APPENDIX 'C'  
Architectural Consultant Review  
&  
Preliminary Materials Board

Architectural Review Report  
Roth Sheppard Architects  
November 20, 2018

**VAIL HEALTH - DILLON  
MEDICAL BUILDING**  
DILLON, COLORADO

**MATERIAL SAMPLES**

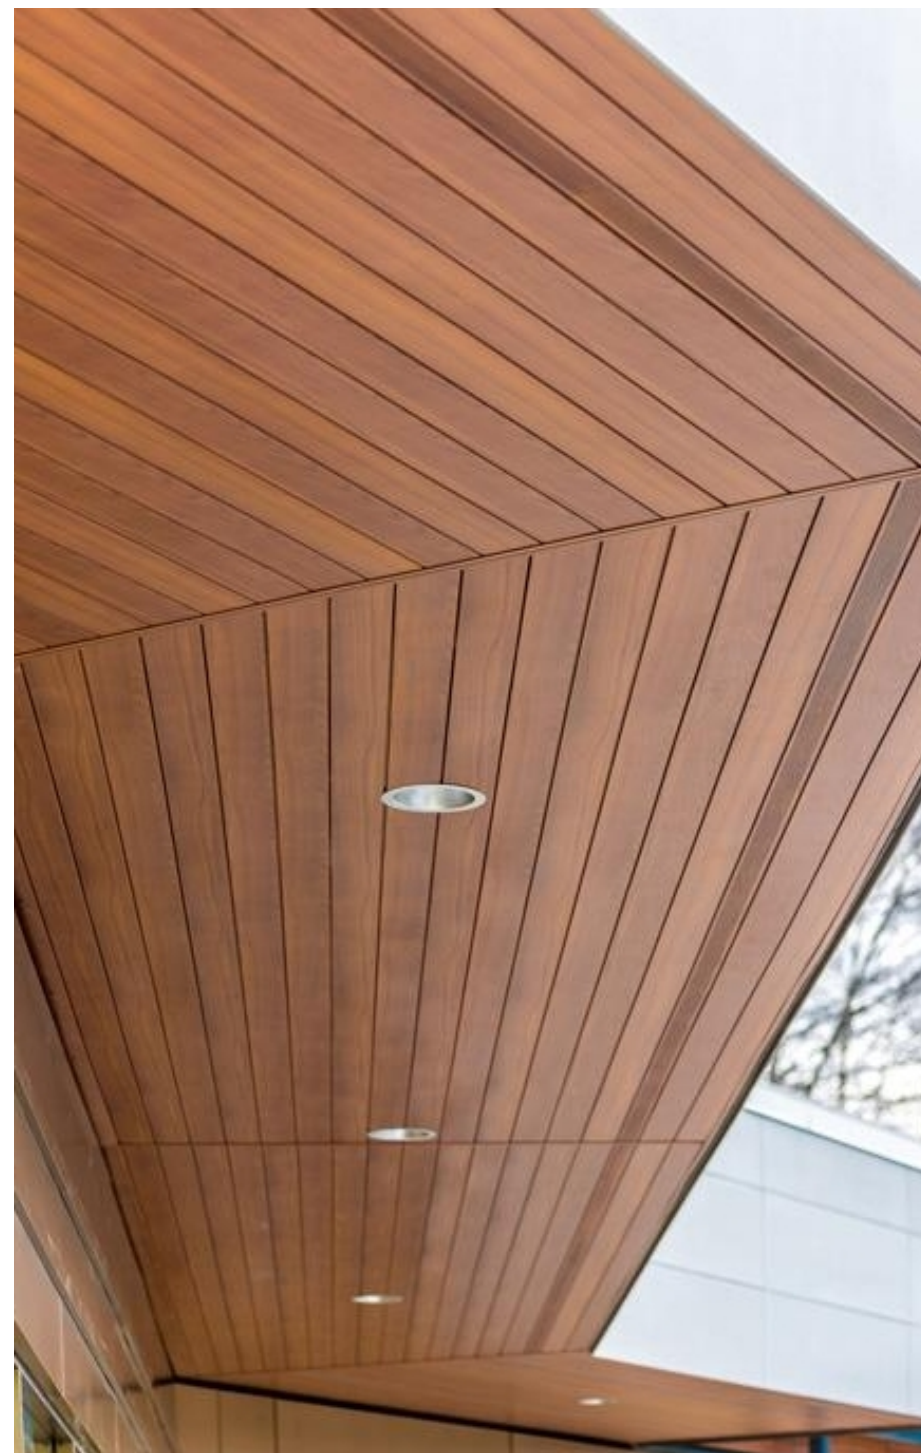
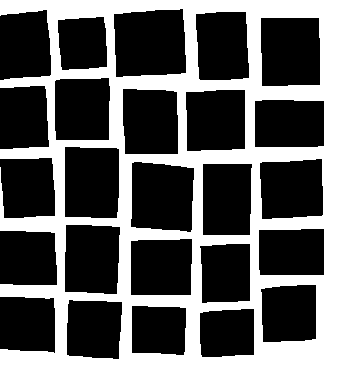
- **No physical Materials Board was provided prior to the meeting, due to pending approvals from Ownership. A digital board was presented during the meeting, which satisfied the requirements for the Applicant to define the proposed building cladding materials. It was discussed that a physical Materials Board will be created for a second review, which will be necessary to ensure the proposed materials are compliant with the Guidelines.**
